**SPR PROJECT # C-09-04**

**VERIFICATION / DEVELOPMENT OF SEISMIC  
DESIGN SPECIFICATIONS FOR DOWNSTATE  
ZONE**

**FINAL REPORT  
JULY 2014**

**University Transportation Research Center  
New York State Department of Transportation  
(UTRC/NYS DOT)**

Fig. 1.1 Comparison of horizontal response spectra of 1000-yr return period: site class D

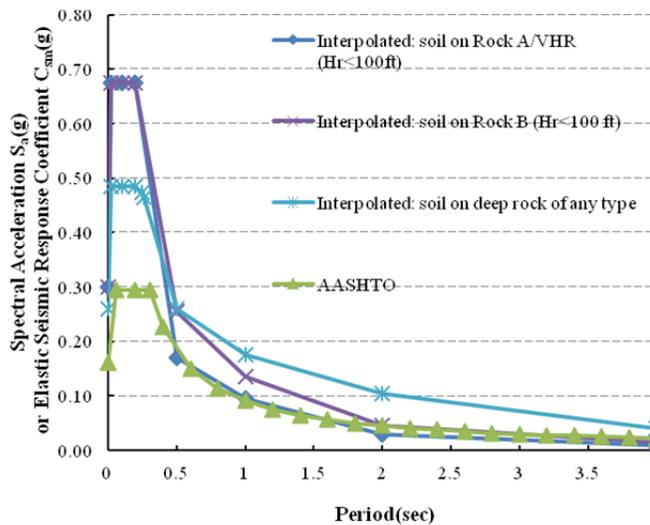
In summary, 1000-yr response spectra developed by the CUNY research team should be used for the design of essential and other bridges in the region. The AASHTO 1000-yr response spectra shouldn't be used for design in the NYS downstate region.

Fig. 1.3 Comparison of response design spectra of rock and soil sites for the 1500-year earthquake: (a): rock class A and soil on rock class A; (b) rock class B and soil on rock class B.

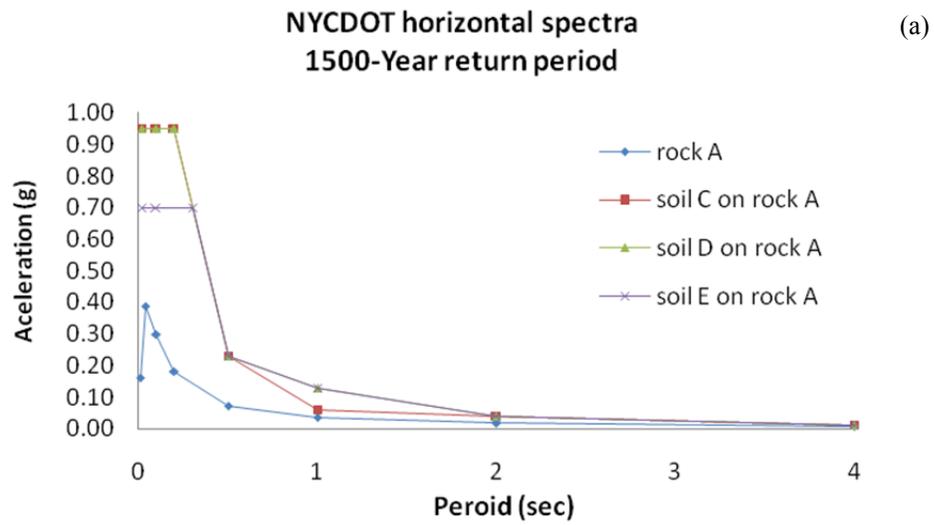
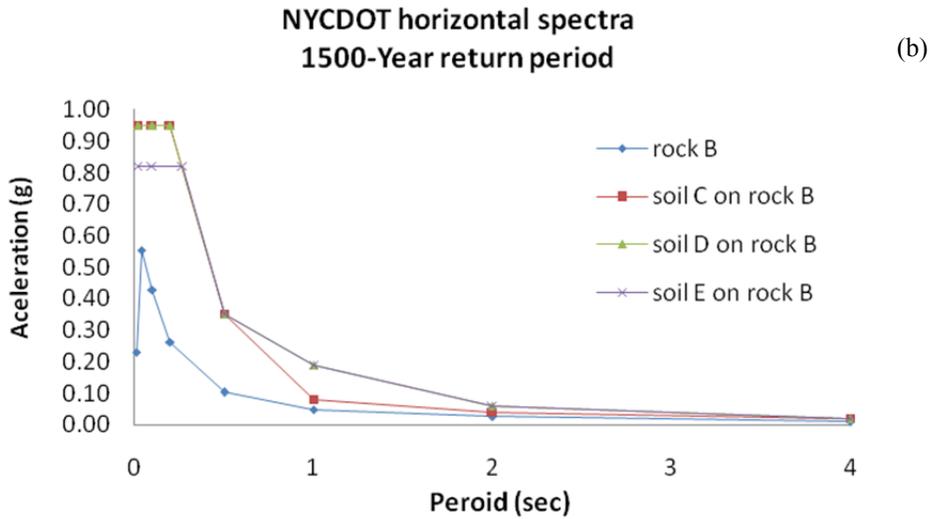
Figs. 1.3 and 1.4 compare the response design spectra on rock and soil sites for two earthquake return periods: 1500 year and 2500 year as proposed in the NYCDOT Guidelines Report. The differences are substantial, as can be expected, and the spectral accelerations at all periods on soil sites ( $H_r < 100$  ft) are much higher than those at the rock sites due to soil amplification. The same trend is also observed for the 500-year earthquake.

Since the depth of footing can be larger than 5 ft in many cases, the proposed criterion may even impose unnecessary seismic demand on a bridge if its footing is close to the bedrock (smaller than 10 ft) but  $H_r > 15$ ft, as can be seen from Figs. 1.3 and 1. 4.

This suggestion has been accepted by NYSDOT.

Fig. 1.7 Deep rock class B profiles analyzed

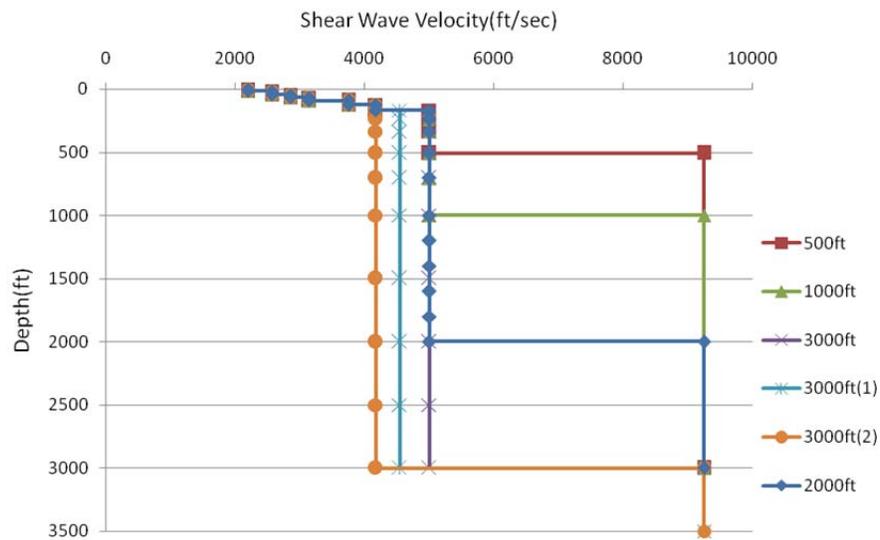
The trend of site factor versus frequency is reversed for thick soft rock profiles above VHR. Since no measured data is available, the existence of any thick soft-rock profile can only be assumed. The Commentary describes analysis of an assumed 3000 ft thick soft rock profile that falls within Rock Class B. The results show site amplifications up to 1.8 at low frequencies (< 1.0 Hz) and values spread around unity at high frequencies (> 10 Hz). The research team conducted Proshake analyses on the same profile described in the

Commentary as well as several other assumed Rock Class B profiles shown in Fig. 1.7. As shown in Fig. 1.8, the results are consistent with those in the Commentary, but also show the dependence of site amplification on the thickness of soft rock and other details of the stiffness profile.

Fig. 1.16 Comparison of horizontal response spectra under 2500-year earthquake: class A bedrock and 5% damping: (a) class C profile; (b) soil class D; (c) soil class E

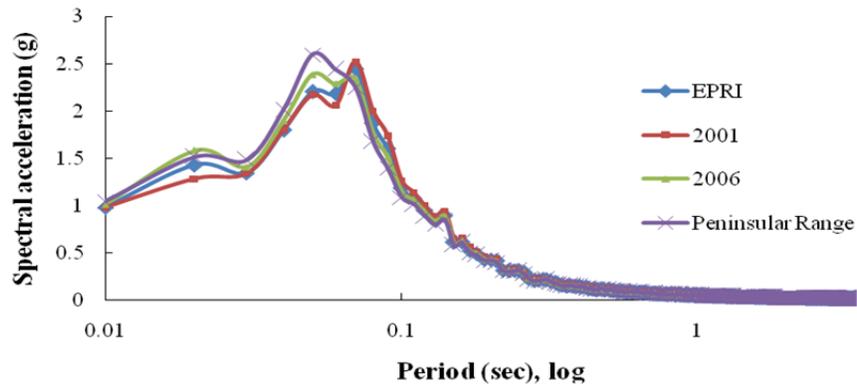
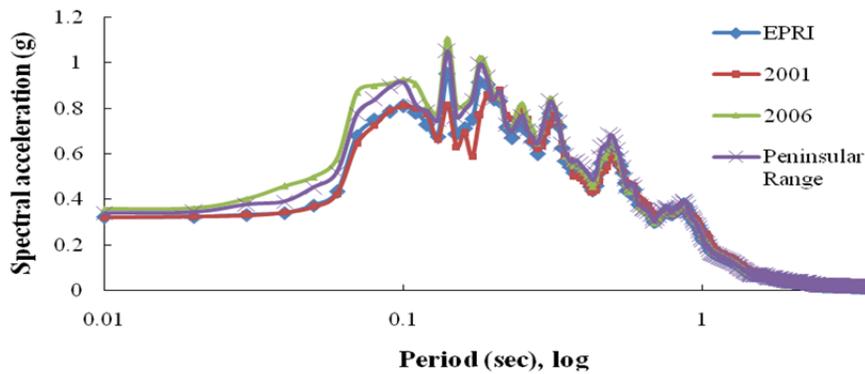
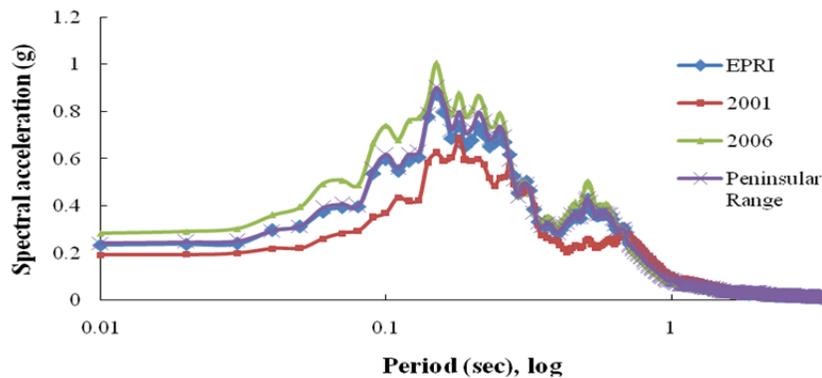
Fig. 1.16 shows some comparisons of horizontal response spectra at the ground surface under the 2500-year earthquake. The 1500-year earthquake was also analyzed and the difference among the three sets of results using different MRD curves was similar to those shown in Fig. 1.16. Overall the differences were small, and as expected, are only apparent at short periods. Fig. 1.17 shows the corresponding maximum shear strains developed in the profiles. The maximum shear strains were generally smaller than 0.2%, which explains the small differences among the three sets of results because the MRD

curves are similar at small strains. The small shear strains also indicate that equivalent linear analysis methods are acceptable for developing the horizontal response spectra in the area. The Commentary to the Guidelines should add a note to this effect.

Fig. 1.19 Magnitude contribution to 2500-year seismic hazard at  $T = 0.1$  sec. in New York City. [From Risk Engineering Report (2002)]

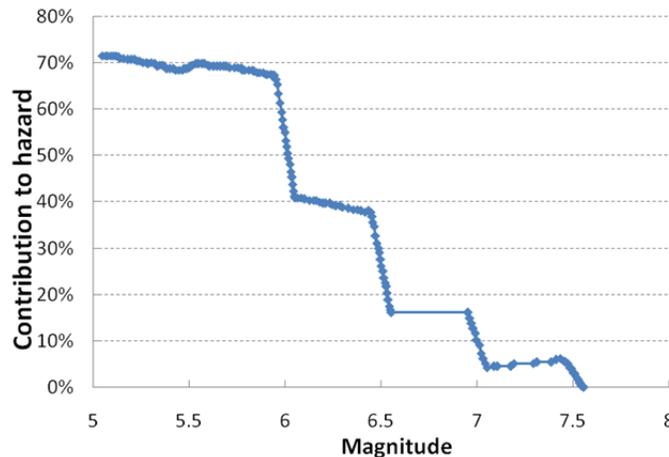
In the proposed NYCDOT Guidelines, a magnitude  $M_w = 6.25$  is suggested for critical bridges for a preliminary evaluation of liquefaction potential. This magnitude is 6.0 for non-critical bridges. The earthquake magnitudes for the two levels of seismic hazard are not strictly based on the disaggregations of the corresponding PGAs. The disaggregation at  $T = 0.1$  sec, as shown in Fig. 1.19, was used in the Guidelines Report to obtain the  $M_w$  for the 2500-year hazard. The magnitude suggested for the 1500-year earthquake was not based on the disaggregation at any period; it was simply assumed to be 6.0 based on  $M_w = 6.25$  for the 2500-year earthquake.

The first and second recommendations above have been accepted by the NYSDOT. Regarding the third recommendation, based on the Weidlinger's team's response, the research team can accept the use of  $M_w=6.25$  for liquefaction analysis of critical bridges, as it is not expected that the deaggregations of PGA and  $S_a$  at 0.1 second would result in large difference. For non-critical bridges, if the 1000-yr motion is adopted,  $M_w=6.0$  for liquefaction analysis should also be sufficient.
